Appendix 2, Page 1 File: OZ/OPA 21-9 W7 Date: 2022/12/23

Recommendation Report Detailed Planning Analysis

Owner: Augend 189 Dundas Street West Village Properties Ltd.

189 Dundas Street West and 3061 Parkerhill Road

Revised Site Plan

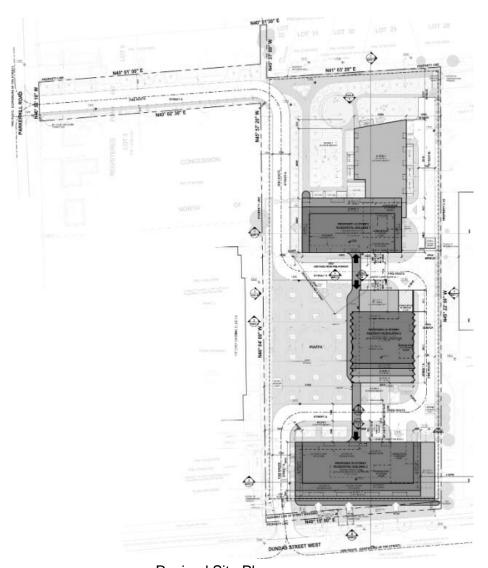
The applicant has provided a revised site plan and elevations, dated November 23, 2022, as follows:

The owners have acquired additional property at 3061 Parkerhill Road and have relocated a proposed access from

Confederation Parkway to Parkerhill Road (proposed access to Dundas Street West remains)

- The internal driveway has been rerouted away from the piazza
- The amenity area has increased from 5 410.5 m² (58,238.1 ft²) to 5 448.4 m² (58,646.1 ft²)
- The non-residential gross floor area has increased from 530.70 m² (5,712.4 ft²) to 576.90 m² (6,209.7 ft²)
- The number of parking spaces have increased from 814 to 826
- The floor space index (FSI) has decreased from 4.19 to 3.78 due to the addition of the Parkerhill Road property
- No change has been made to the proposed building heights
